# **Monitoring Report MY05**

**Stony Fork Restoration Site  
Upper Neuse River Basin - 03020201  
Monitoring Year 05  
DMS Contract 6830**

## MEMORANDUM

Date: February 26, 2024  
To: Danielle Mir, DMS Project Manager  
From: Adam Spiller, Project Manager  
KCI Associates of North Carolina, PA  
Subject: MY-05 Monitoring Report Comments  
Stony Fork DMS #6830, Contract 006830  
Neuse River Basin CU 030202018  
Johnston County, North Carolina

CURRENT CONDITIONS PLANVIEW  
 STONY FORK RESTORATION SITE  
 JOHNSTON COUNTY, NC

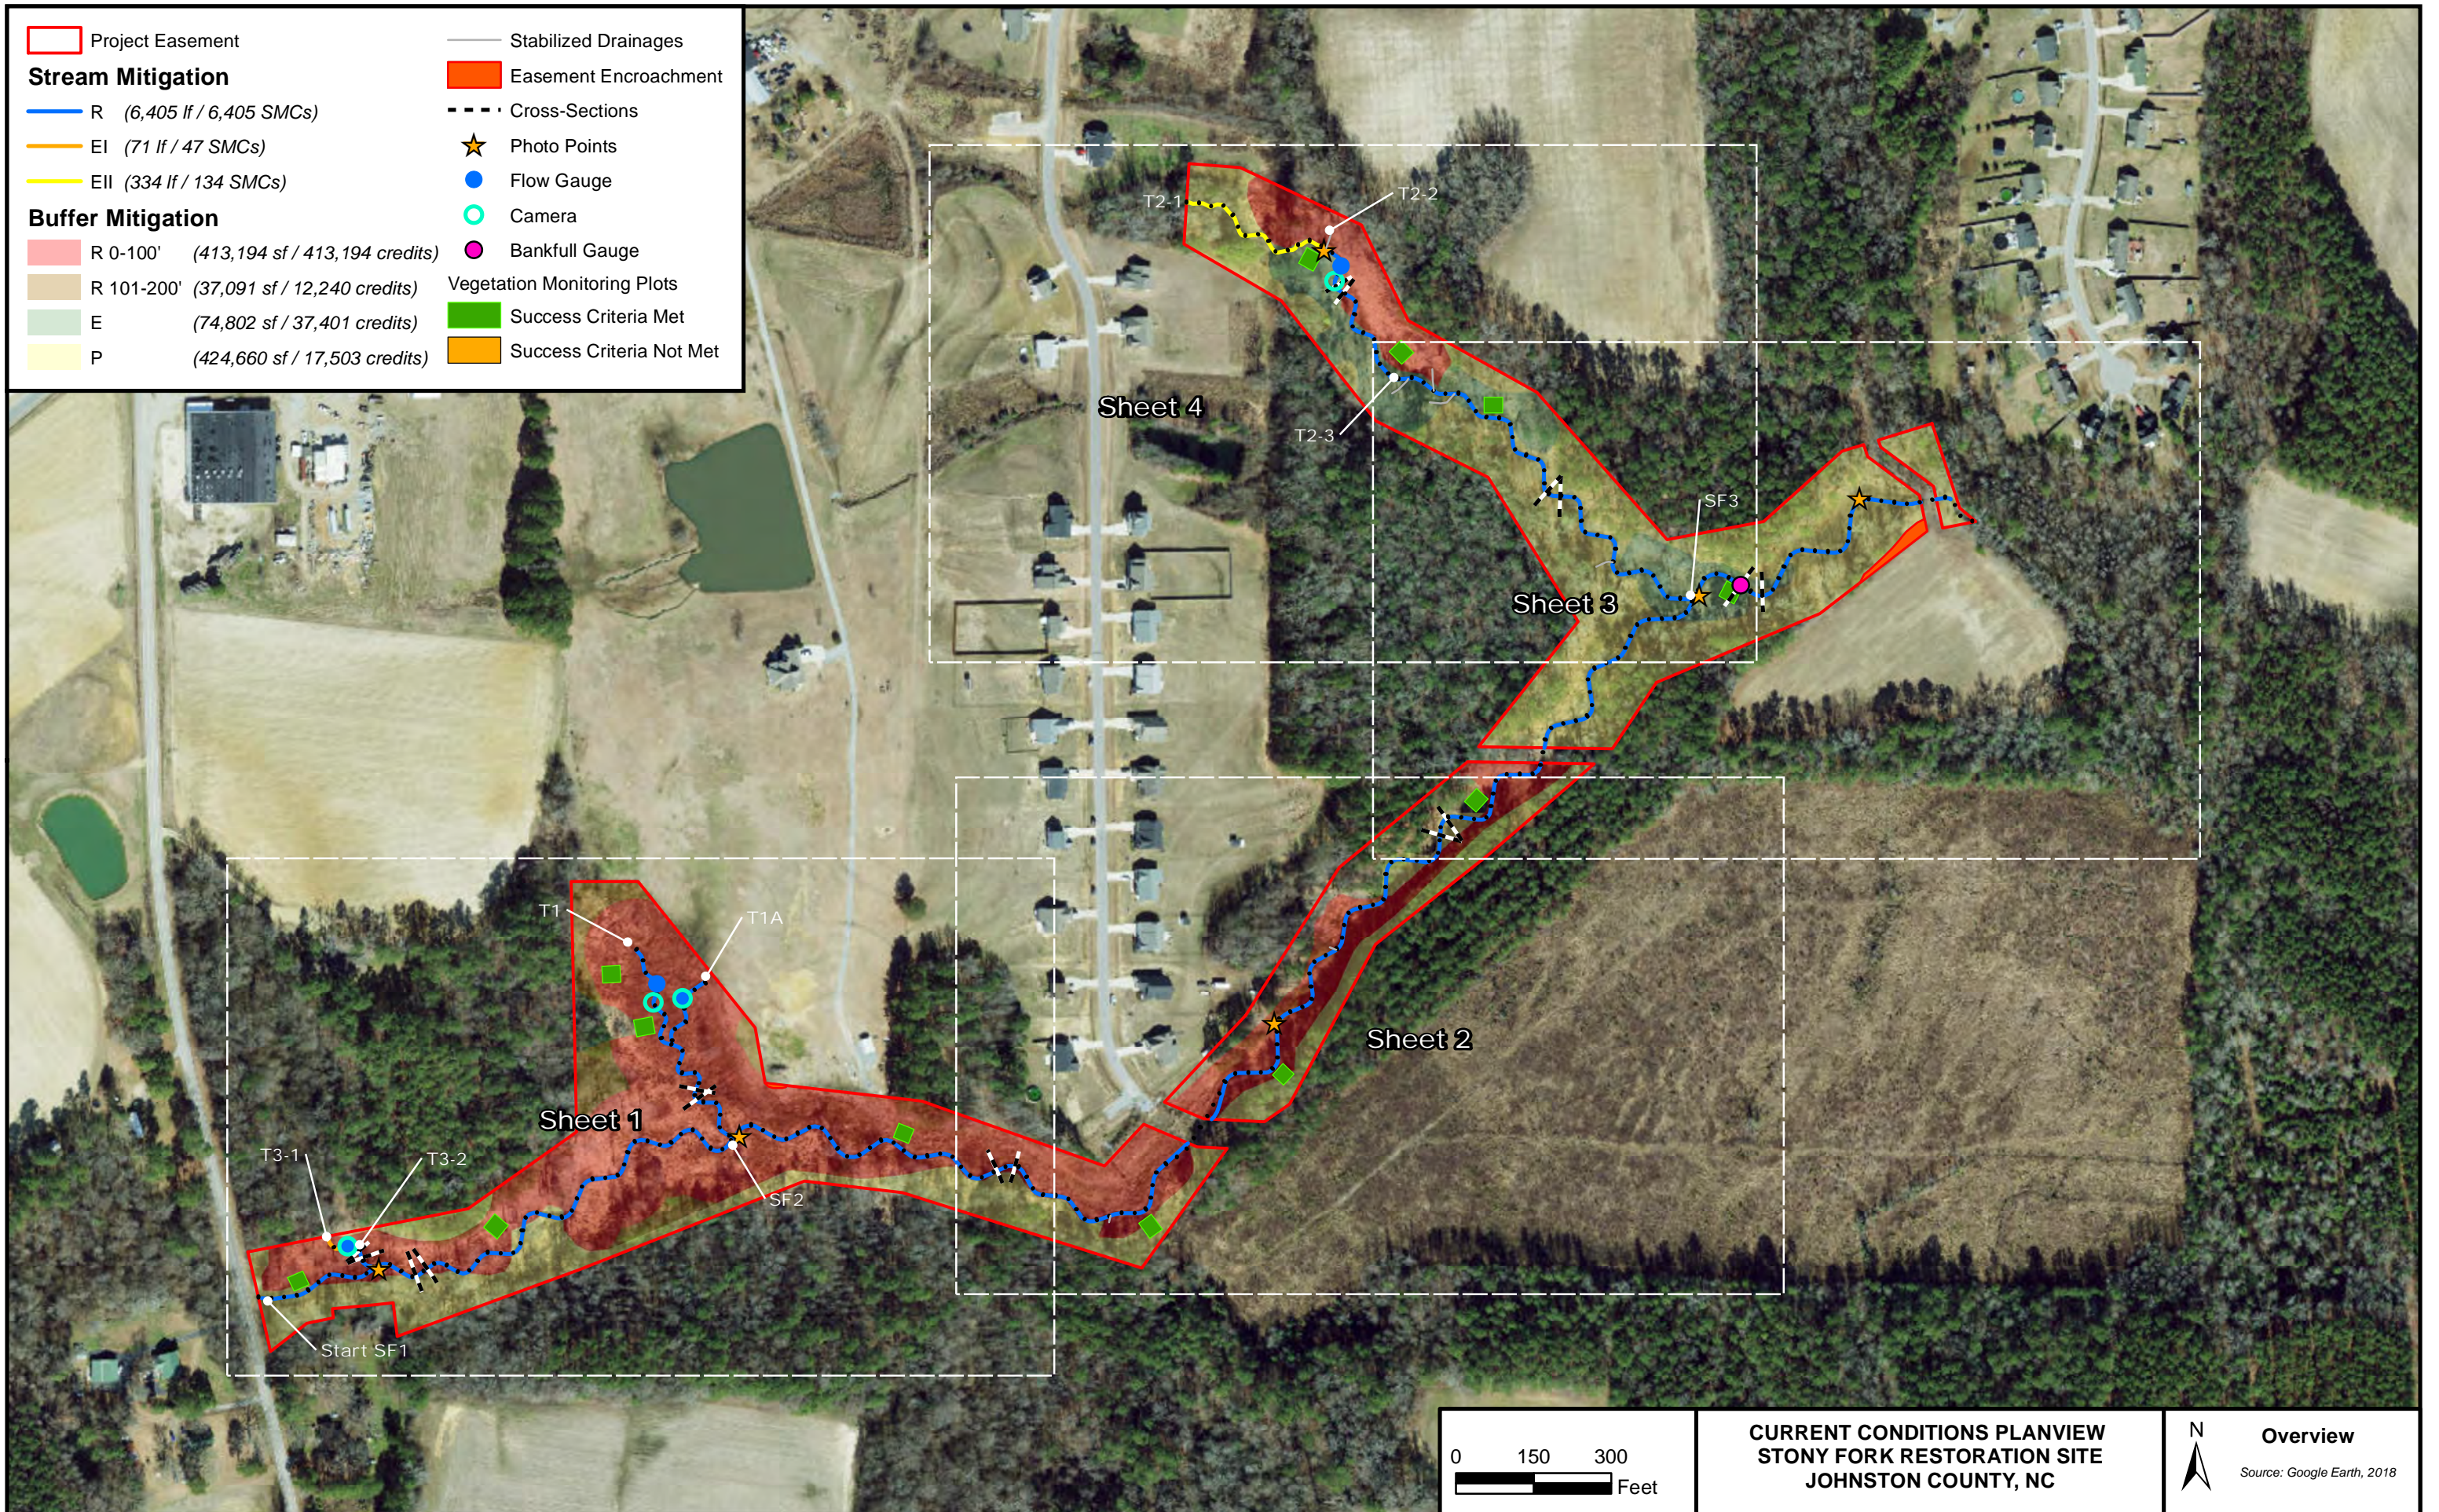
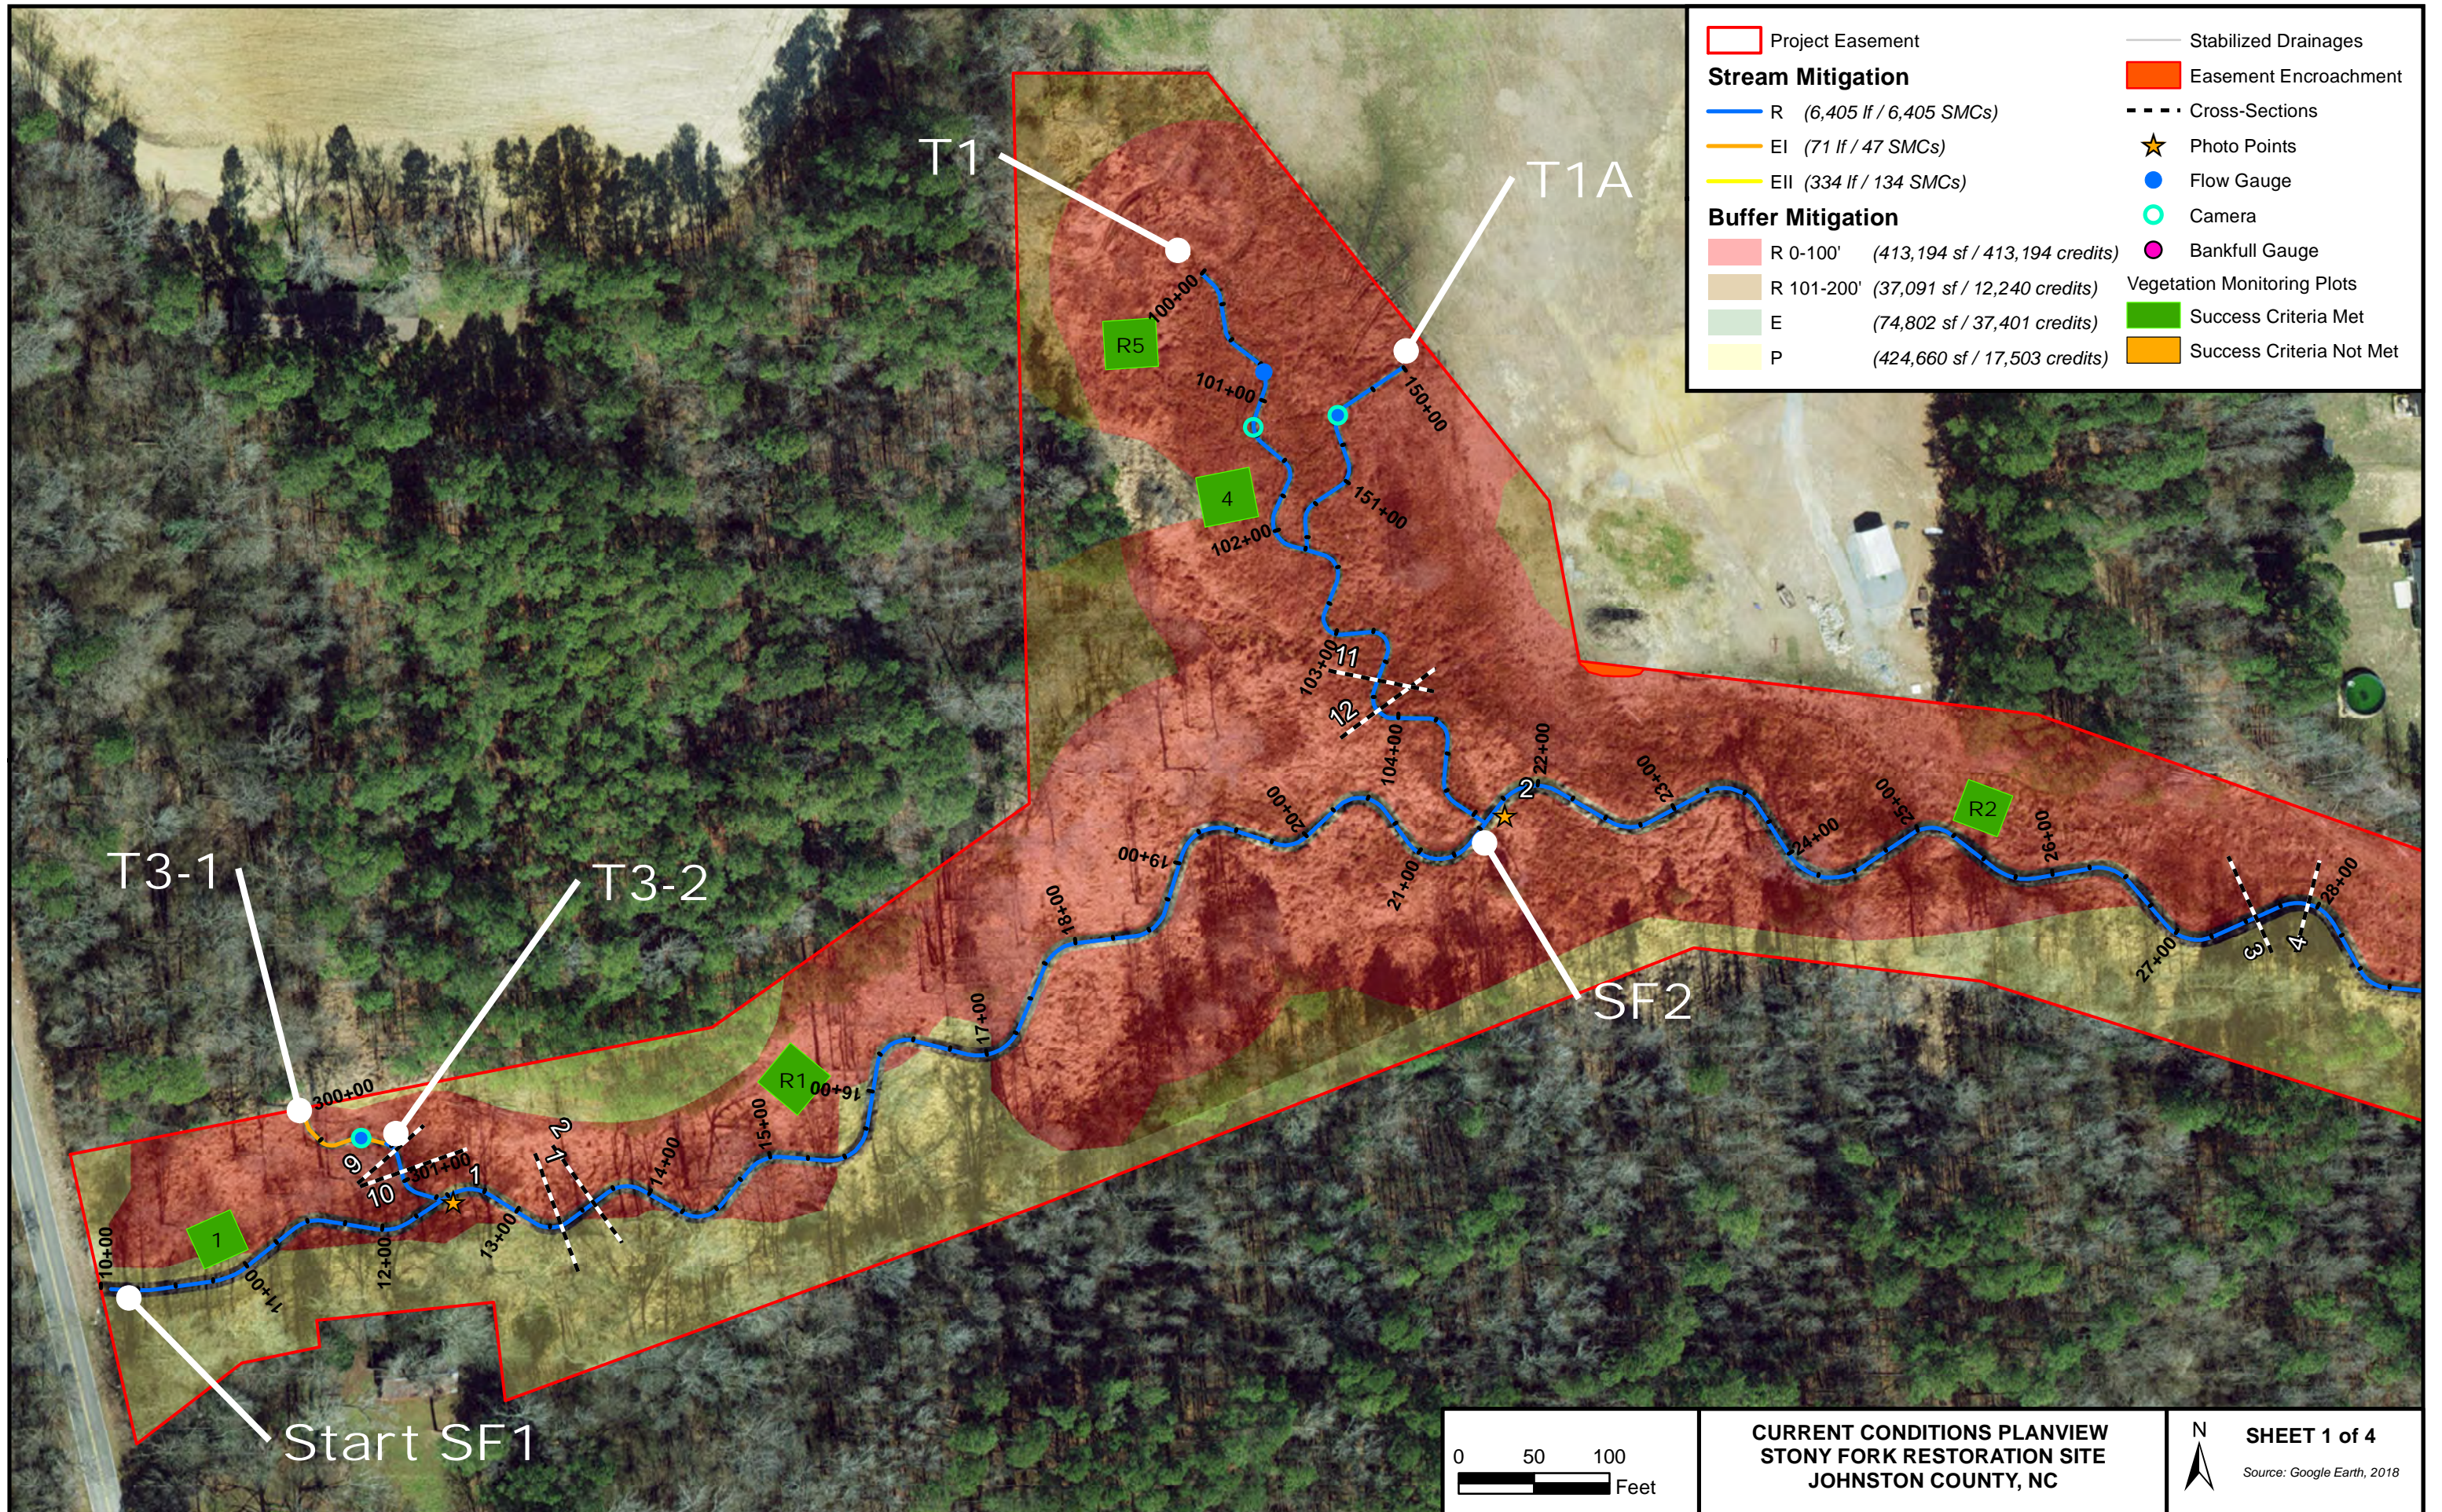
1. Table 1 - Please display credits to 3-decimal places.  
*KCI Response: This error has been corrected.*
2. CCPV – DMS recommends showing the non-credited streams inside the easement with a symbology of a grey /black line labeled “non-credited stream.” Below is a rough sketch of the estimated locations of these streams.  
*KCI Response: At the start of the project, the features in question were determined to not constitute streams. These ephemeral drains were stabilized as part of the project and have been added to the CCPV and labeled “Stabilized Drainages.”*
